N4906B-03

S E R V I C E N O T E

N4906B - Serial BERT

Software Update Required

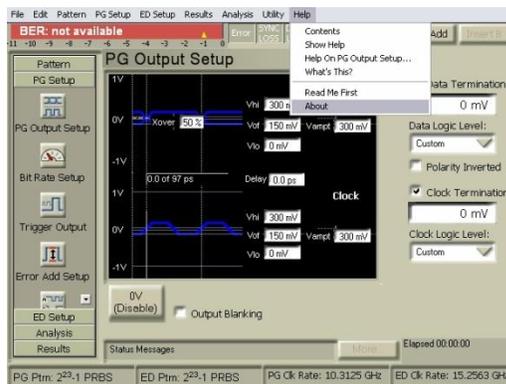
What will happen if the software upgrade is not done?

Only the version 3.53 of the software (or later) is “able to deal correctly” with the new component in those parts. If the software is not updated to the latest revision (3.53 or later) the software of the instrument will not start correctly.

You will get **self test errors** as shown in the next picture:

Please keep in mind: please do a software upgrade to 3.53 or later starting Nov 1, 2010 regardless whether you use old or new. From the outside it is not visible whether the part (N4901-60520 or N4901-69520) contains the new or older component.
